WOODMEN HILLS METROPOLITAN DISTRICT

LIFT STATION #1 REPLACEMENT

100% DESIGN DRAWINGS

OVERALL EXISTING SITE PLAN

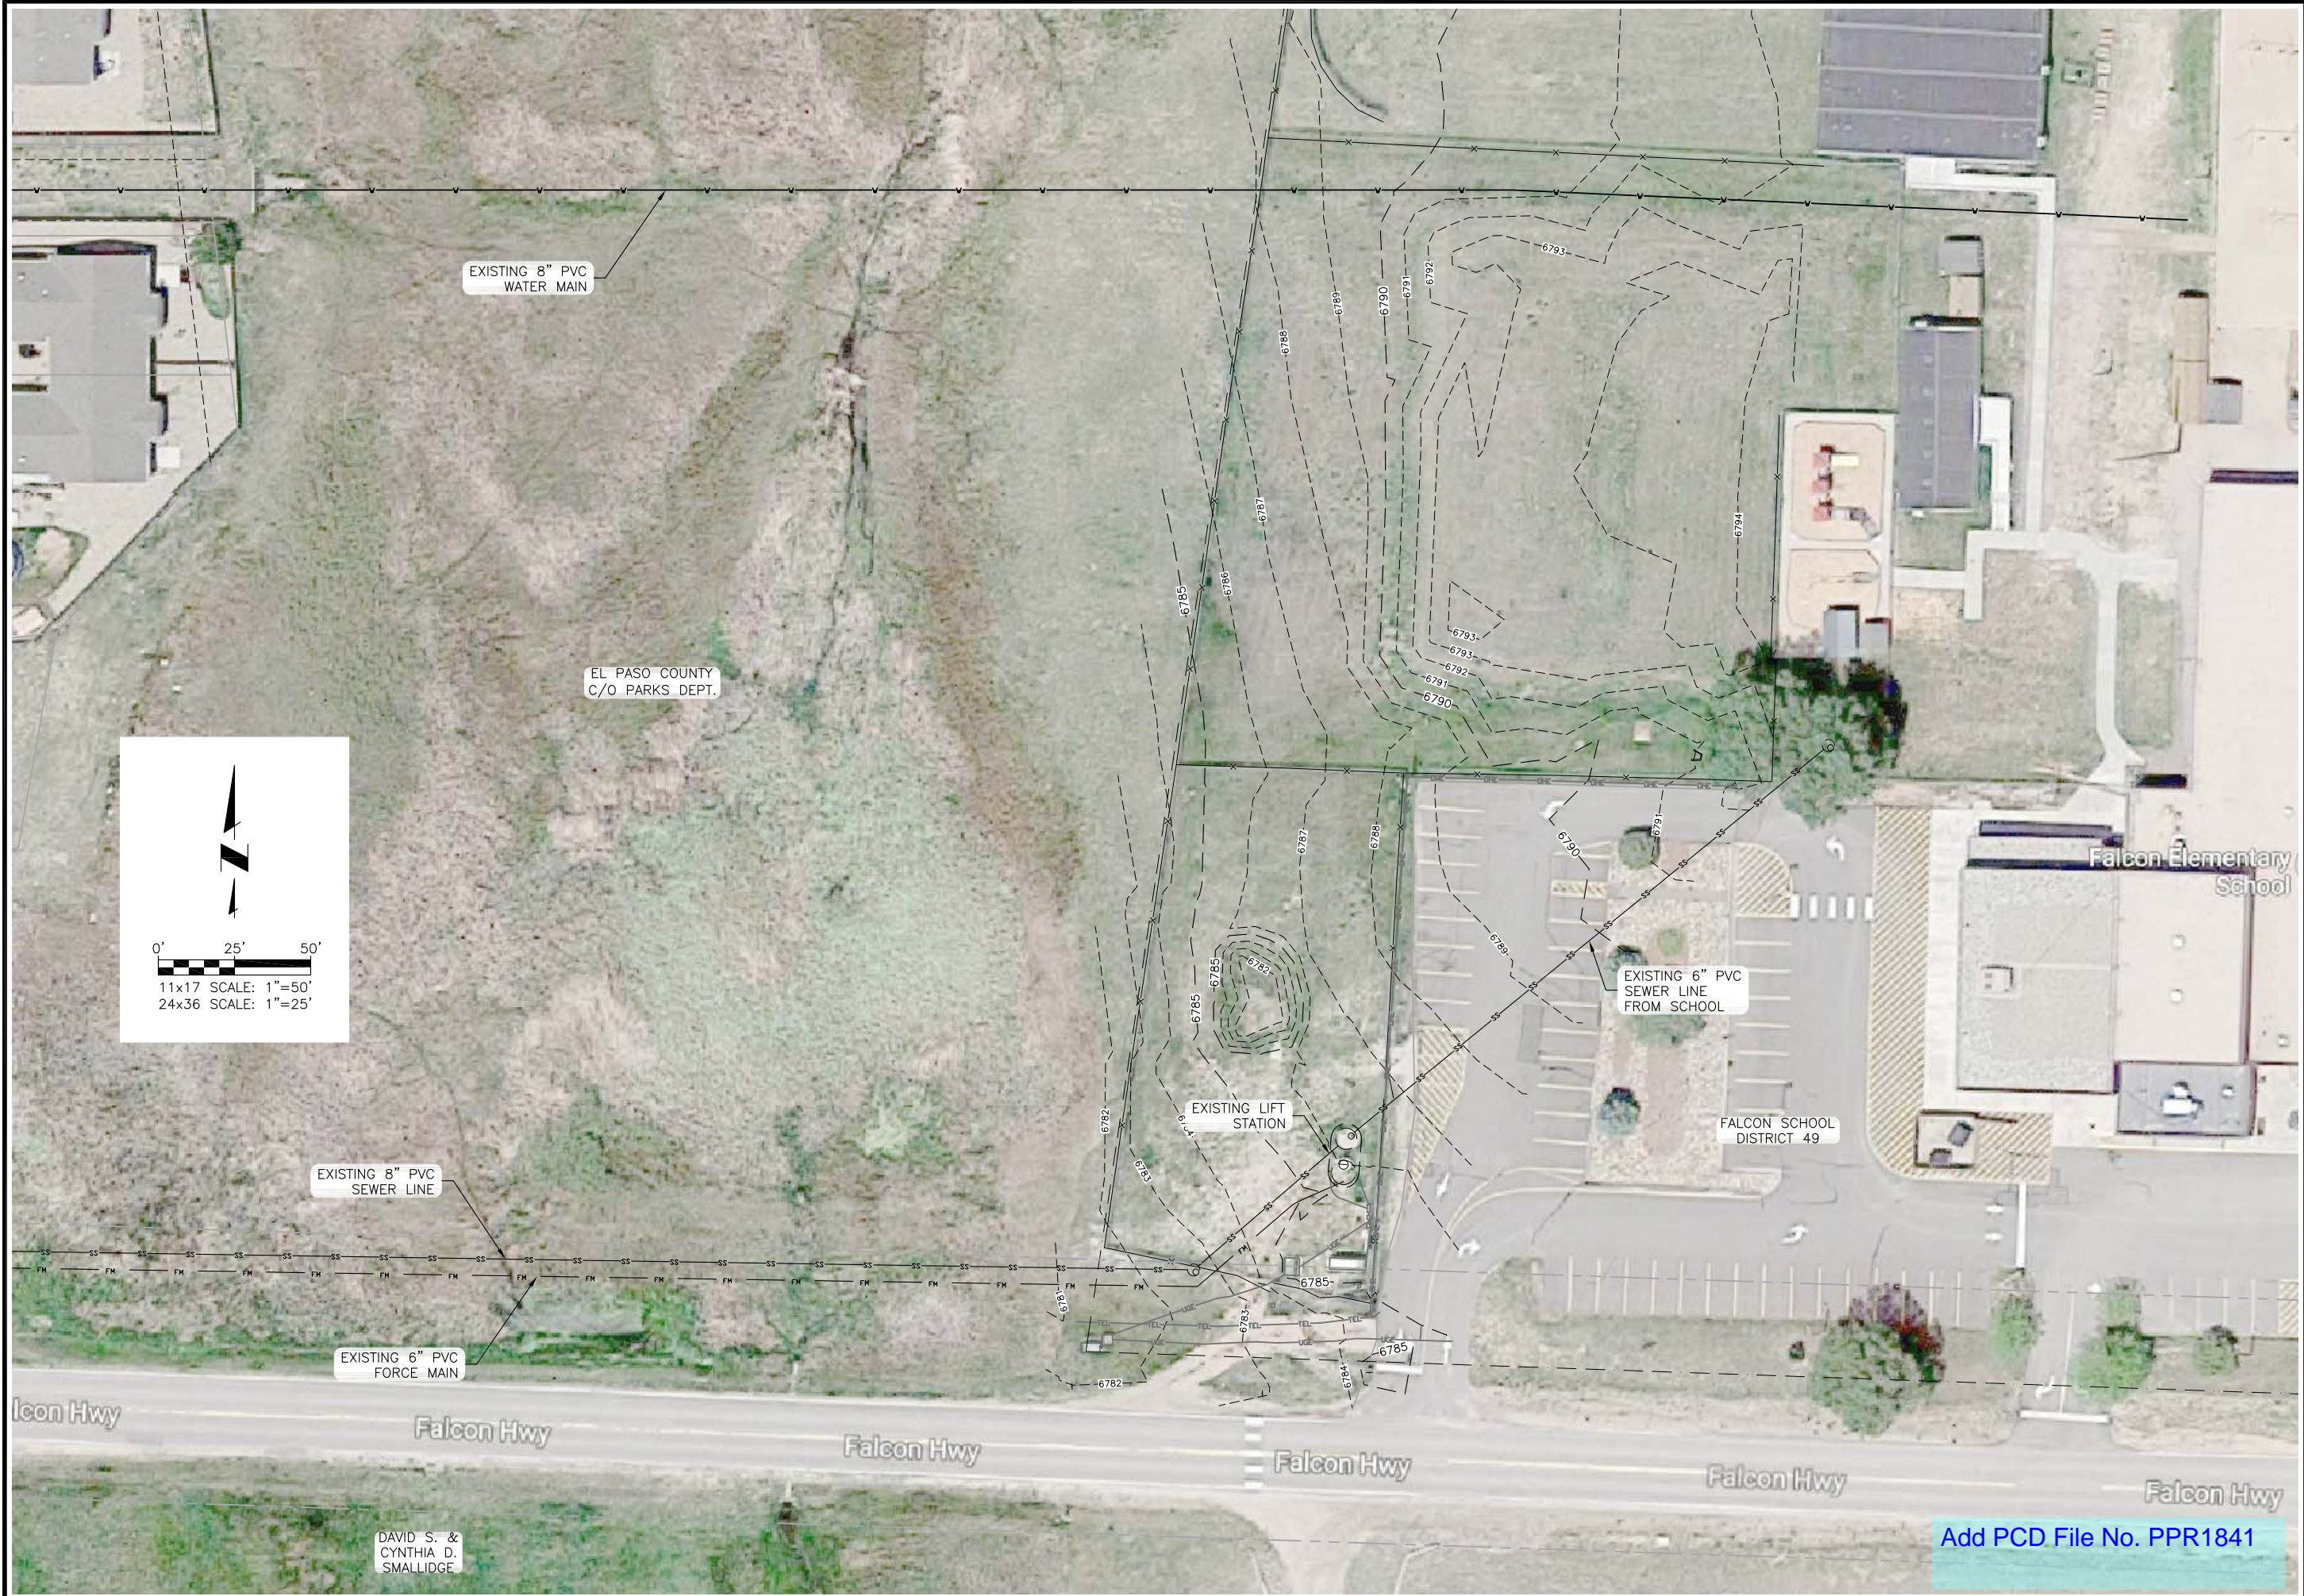
Add PCD File No. PPR1841

WOODMEN HILLS METROPOLITAN DISTRICT
LIFT STATION #1 REPLACEMENT
OVERALL PROPOSED SITE PLAN

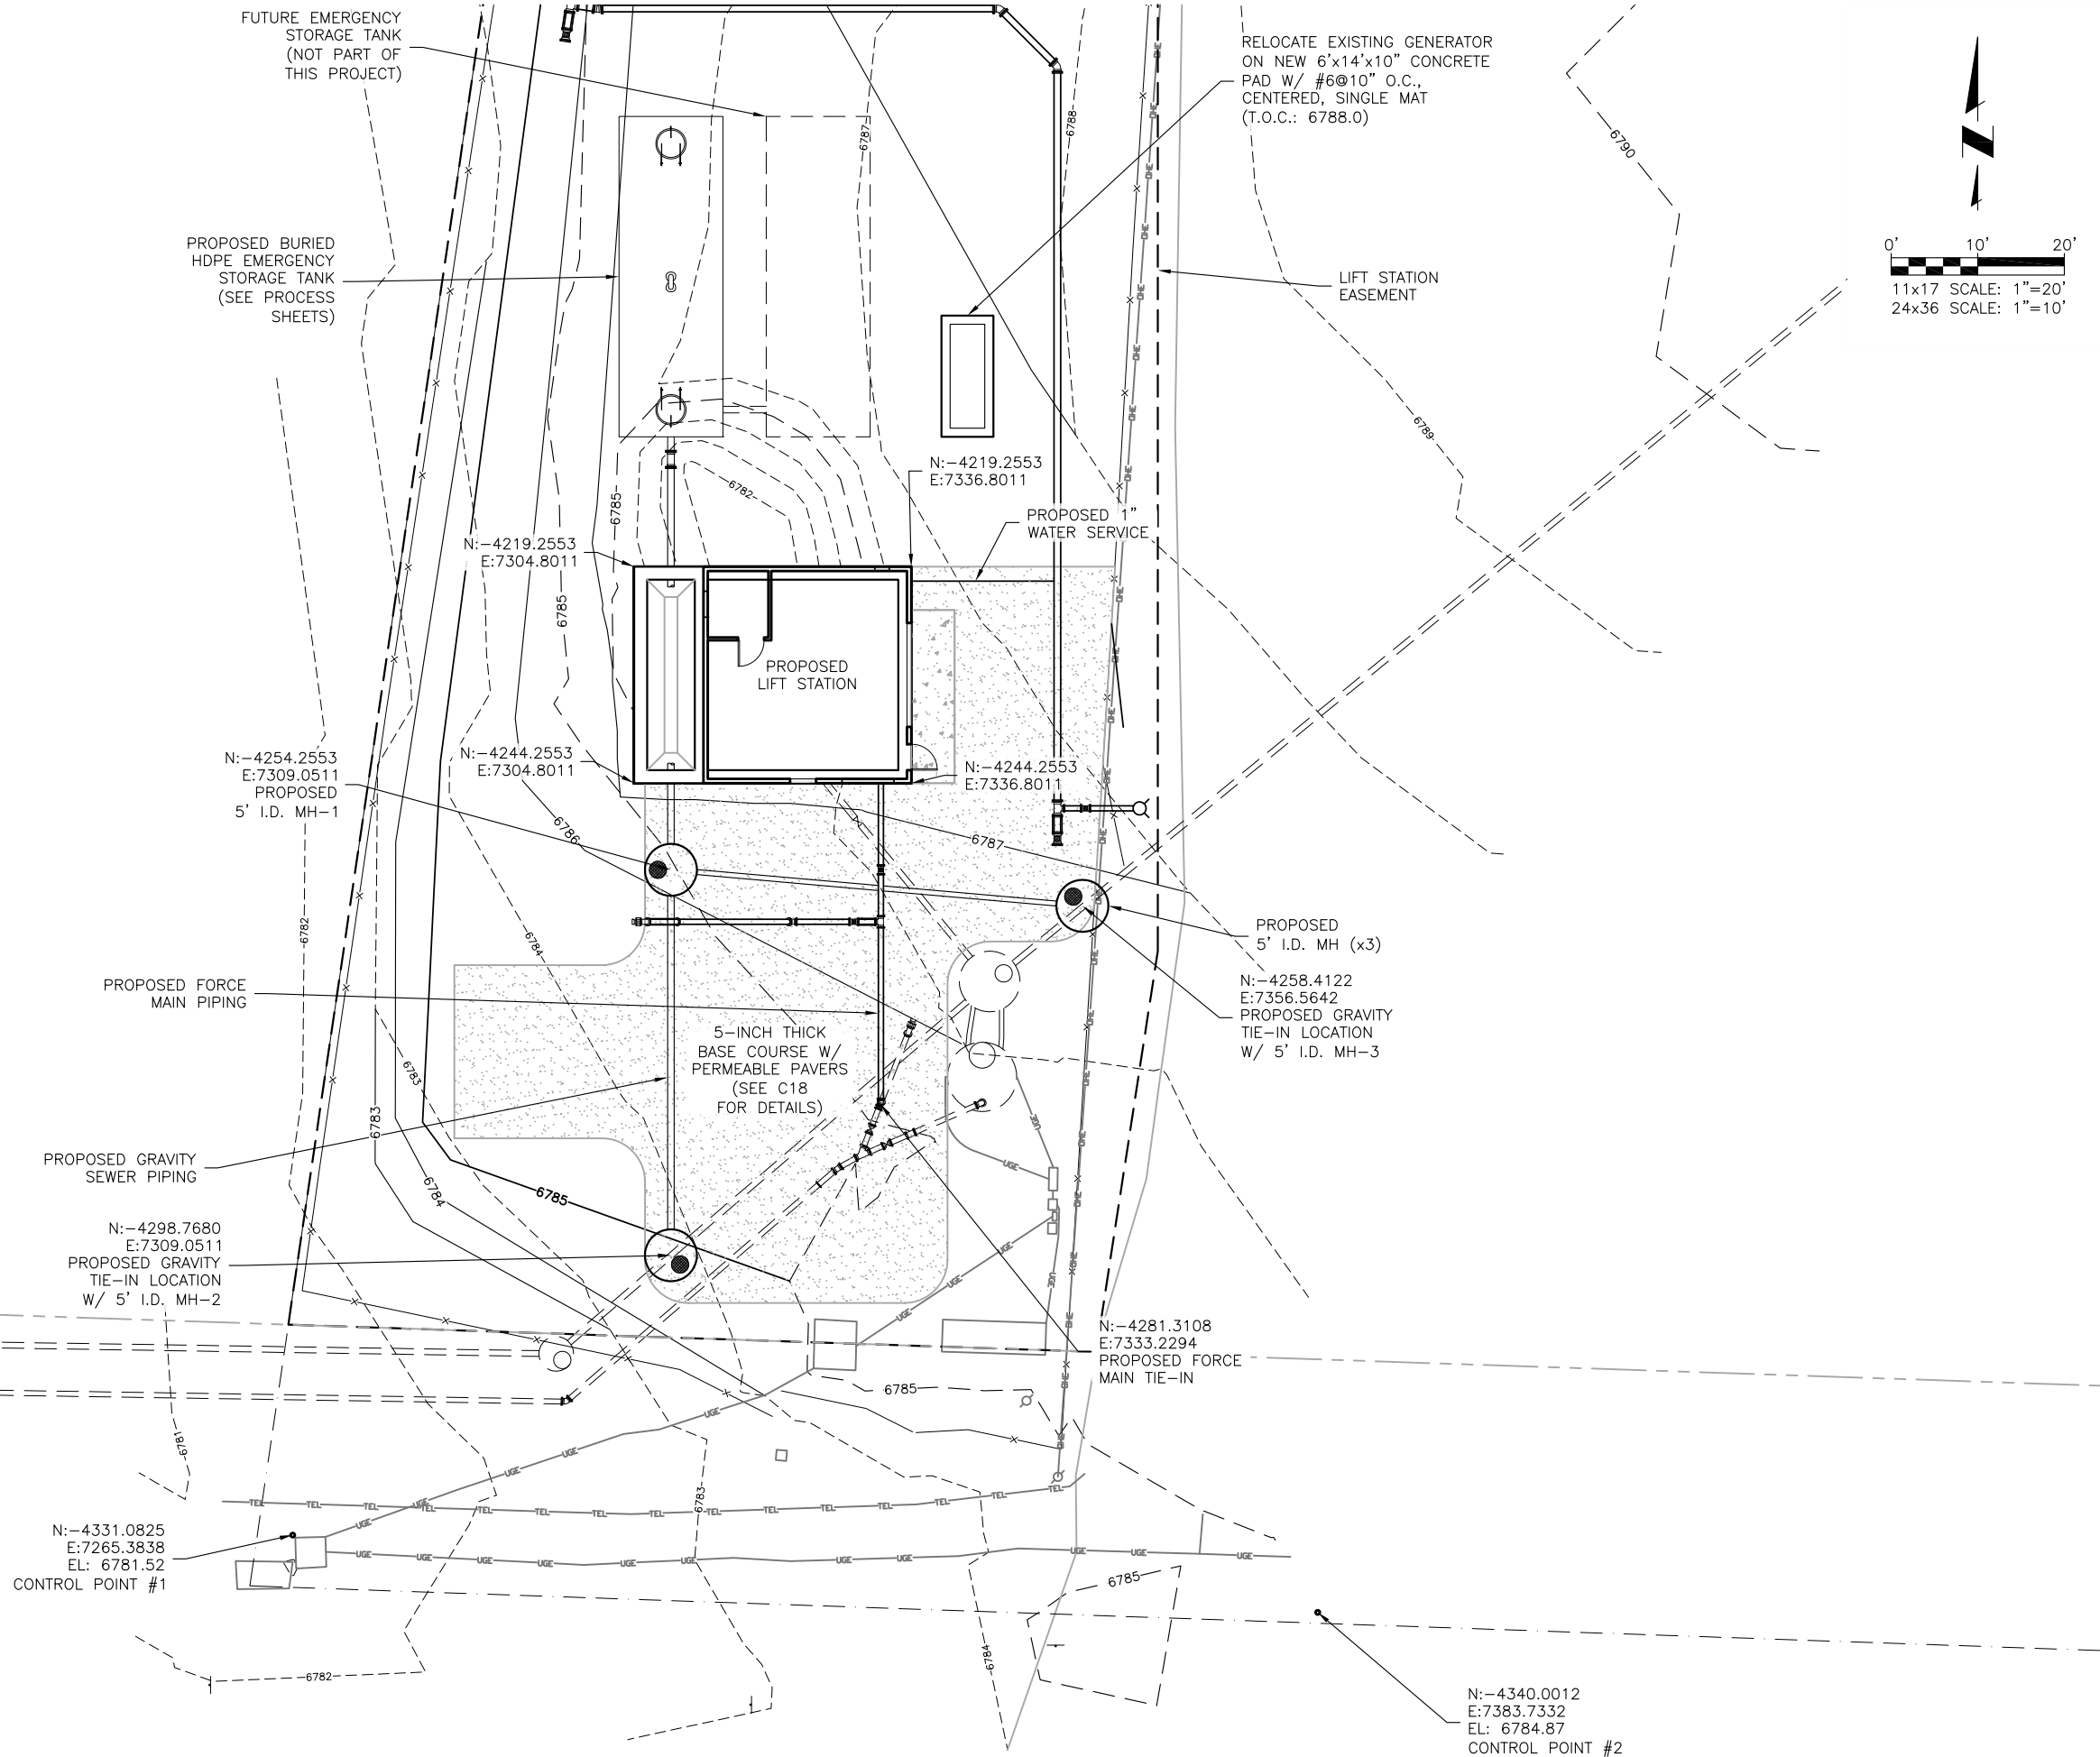
Provide dimension of all easements.

Identify adjacent property owners by name or platted subdivision name.
Provide this on all site plan sheets

Show the FEMA flood plain on the plan.
Provide this on all site plan sheets.

Provide a vicinity map.

Provide dimensions from all facilities to the closest property line.

•Provide legend and/or label various line types. Provide on all site plan sheets.

Show the setback distance from the property lines

Include this note on the plan.

The parties responsible for this plan have familiarized themselves with all current accessibility criteria and specifications and the proposed plan reflects all site elements required by the applicable ADA design standards and guidelines as published by the United States Department of Justice. Approval of this plan by El Paso County does not assure compliance with the ADA or any regulations or guidelines enacted or promulgated under or with respect to such laws.
